Fresenius Medical Care SERVICE BULLETIN

Equipment: Granuflo Mixer
Bulletin: 00-GRN-001
Subject: New Style Mixer Motor Coupler

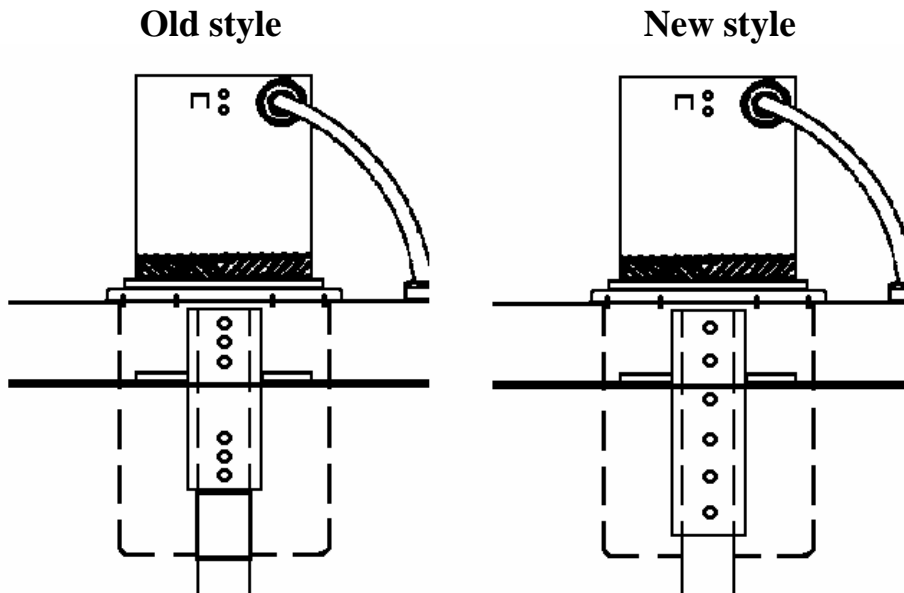
The coupler that attaches the Granuflo mixer motor to the shaft has changed. There are two reasons that the coupler was changed. The first reason is that the new style coupler is longer allowing more space between the screws for a better hold. The second reason is that the new style coupler is longer eliminating the need for the white spacer. The new style coupler is the same part number as the old one (G84-001-15), but the part number for the screws has changed from G26-263 to 330045-03-01. As always you must leave 1/8" between the Granuflo mixer motor and the coupler but with the longer new style coupler you do not use the large white spacer.
